September 14, 2021

Pearl High School Indoor Training Facility
Pearl, Mississippi

ADDENDUM NO. 04

GRADING PLAN
SCALE: 1"=20'-0"

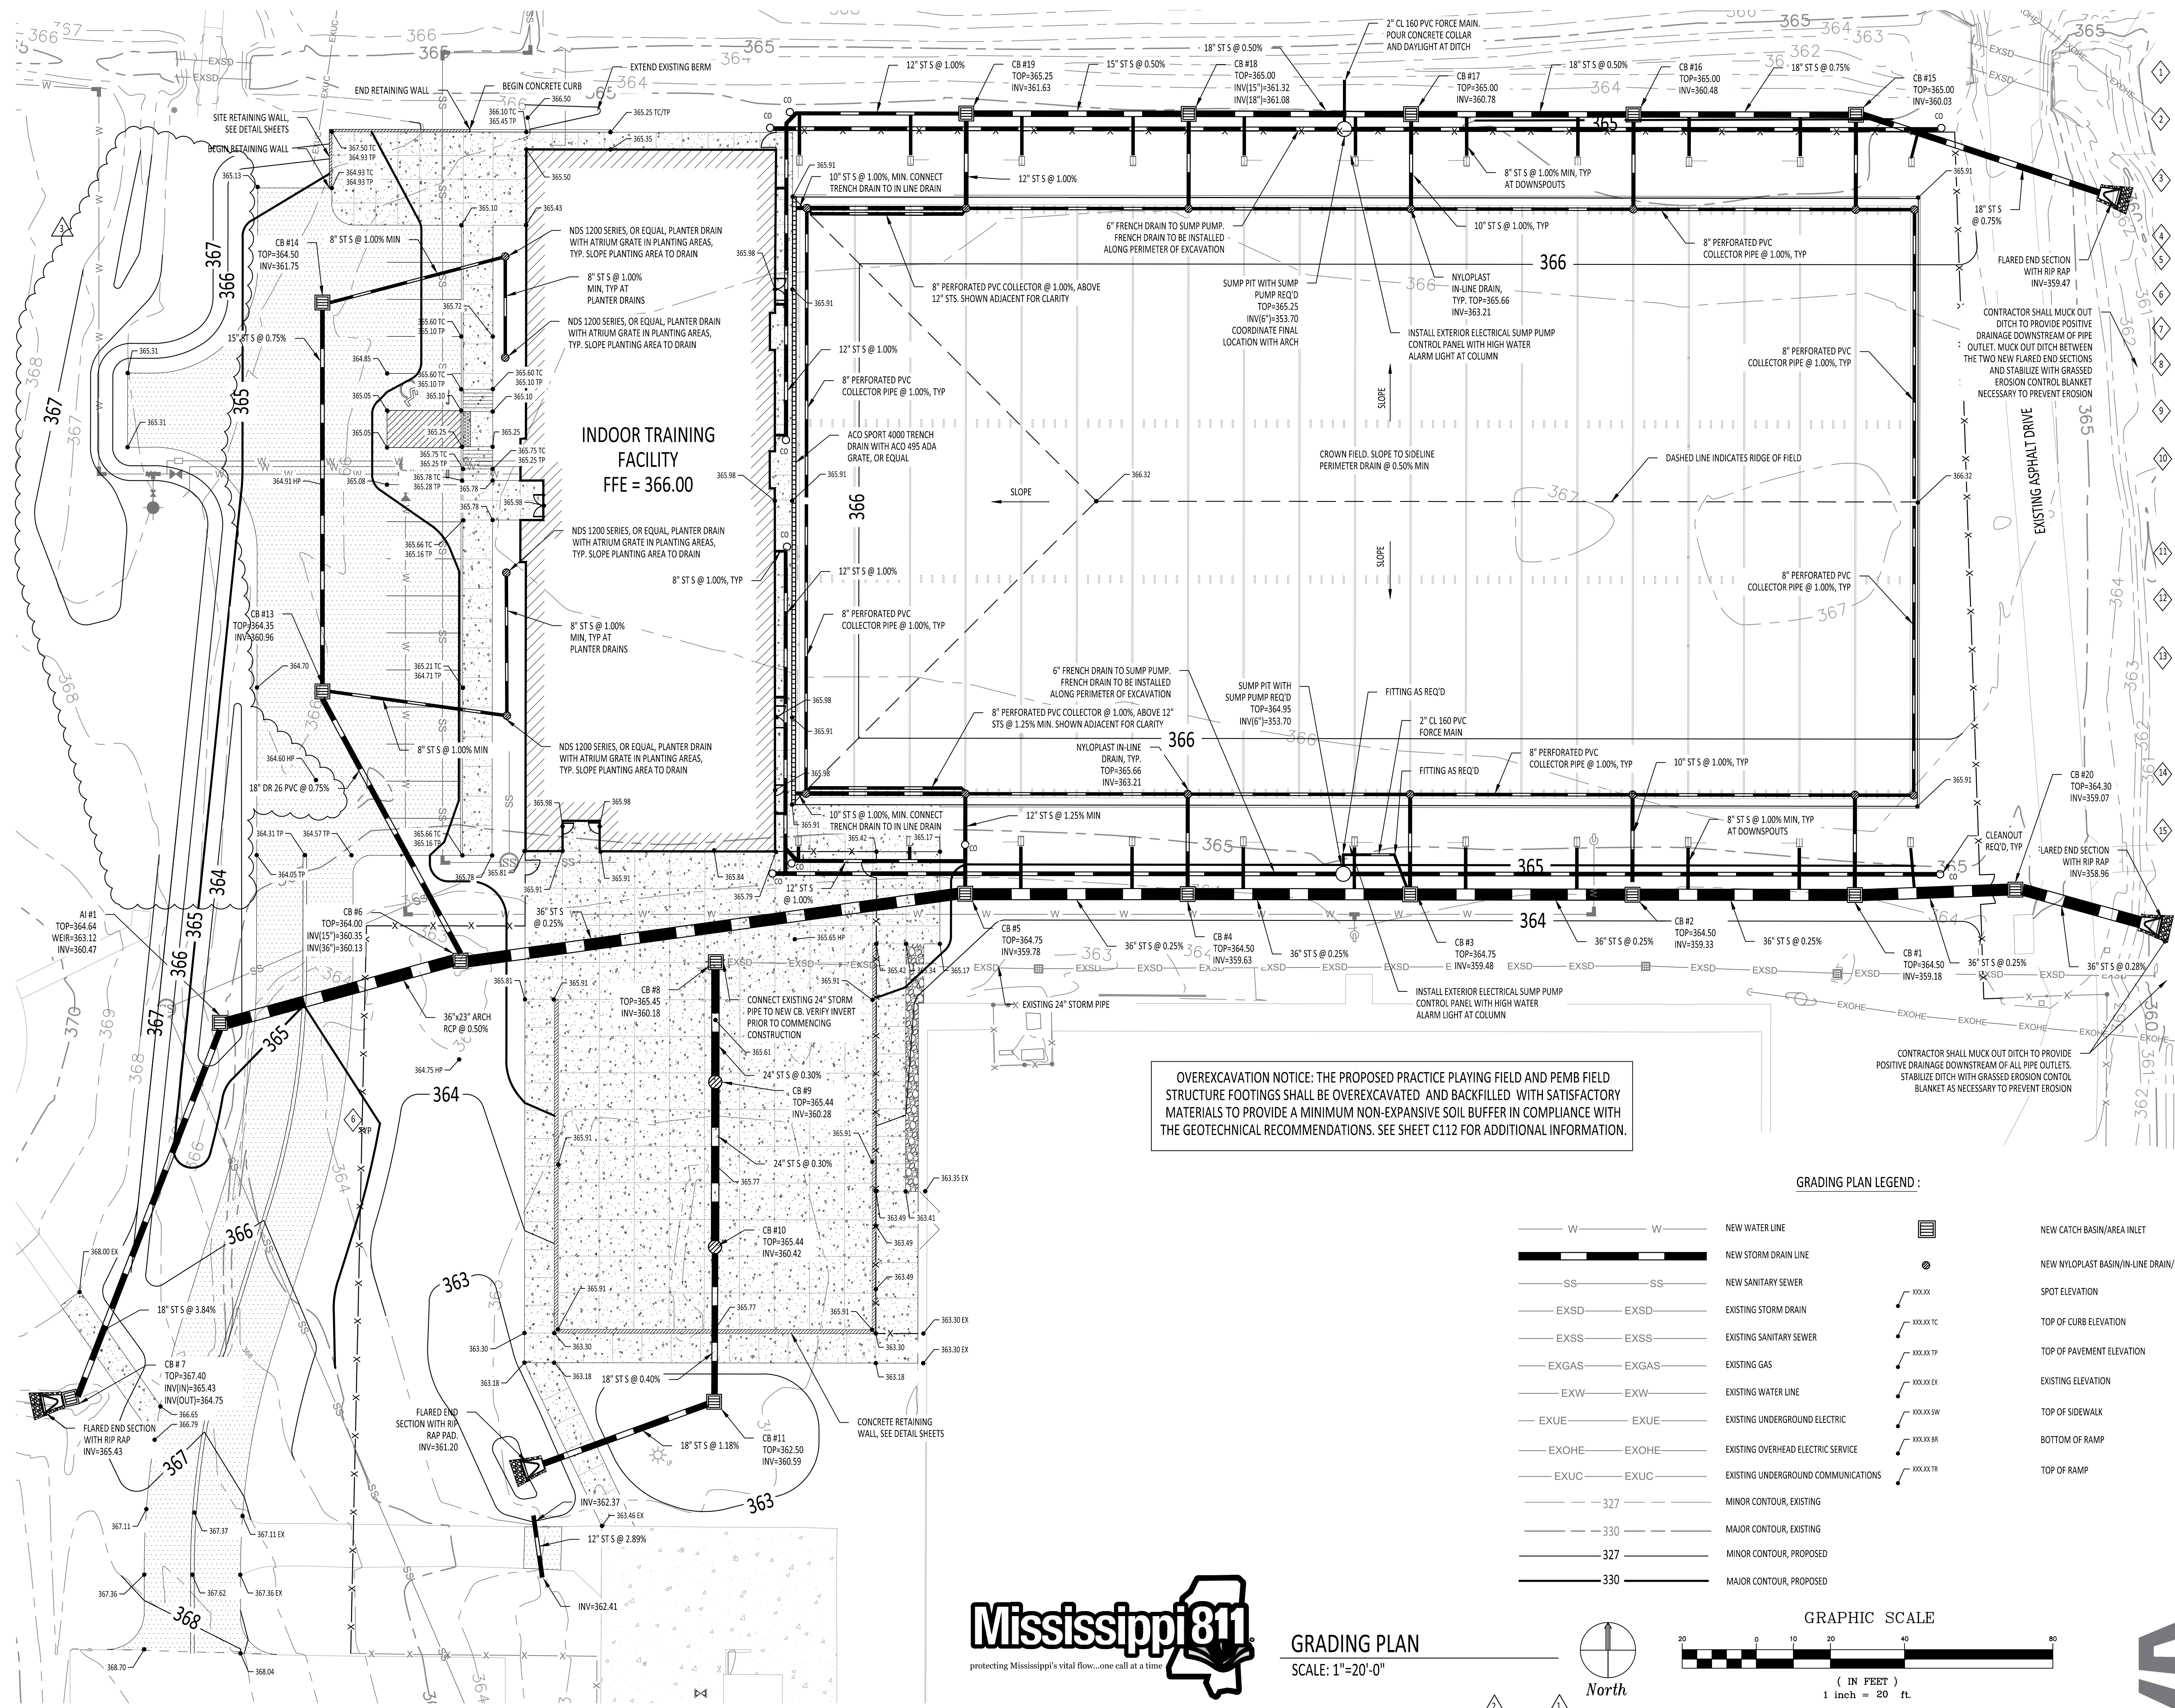
- ITEM NO. 03 C131 GRADING PLAN**
Revise per the enclosed sheet.
- ITEM NO. 04 C202 CIVIL DETAILS**
Detail 1/C202
Revise 6" ACC Base Course; MDOT BB-1, Type 6 to be **4" ACC Base Course; MDOT BB-1, Type 6.**
Remove note 7. Lime treatment of subgrade soils below pavement is not required.
